Institute of Refractories Engineers

Exercise Feedback

Training Day 2017

Sheffield
8 November 2017

Build up Zone

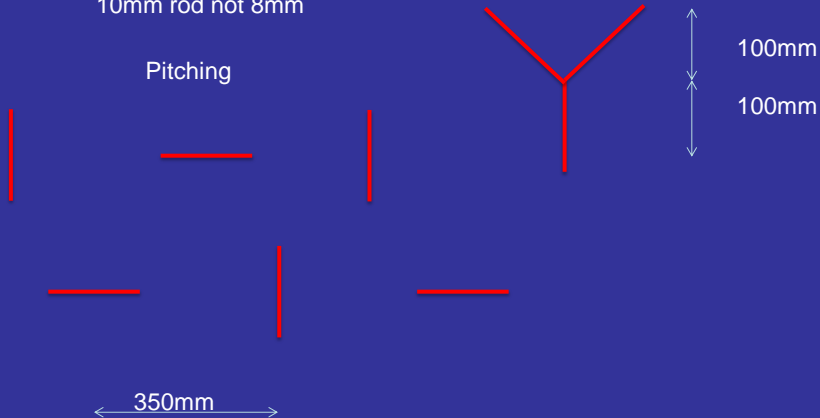
As a floor, less anchors than for walls?
Forces from build up removal? More anchors? Thicker?

10mm rod not 8mm

Roof

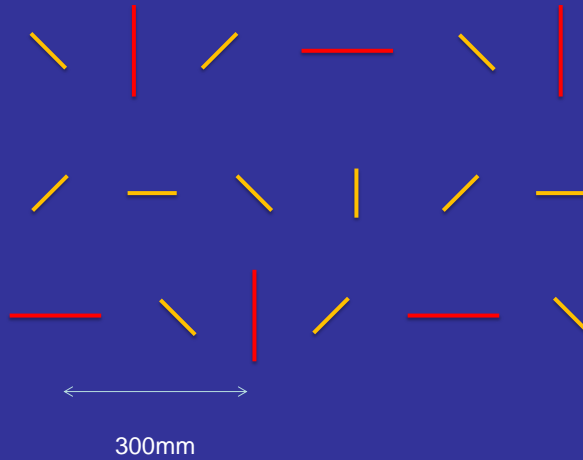
Need to support insulation and hot face.

Separate anchor for insulation

Burner Branch

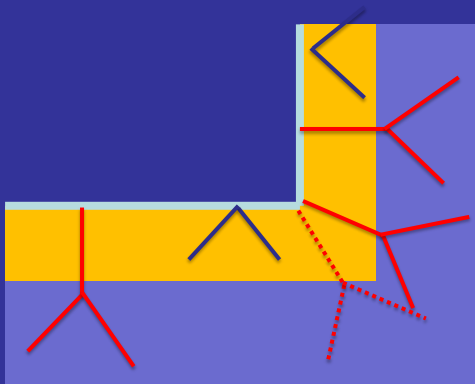
Main Branch – Thermal Shock, Varying temperatures
Anchor as for roof

Connection with roof

Waste branch in Roof

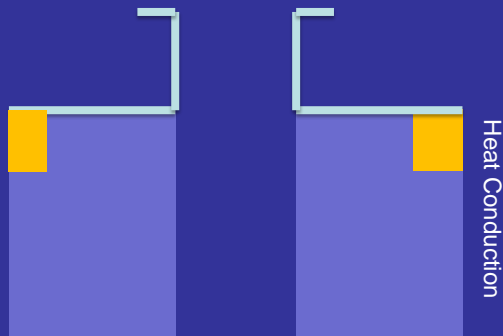
Is feed continuous?
Corrosive? Abrasive dusts
Often get a branch through the lining

If no liner is needed then need dense lining to shell
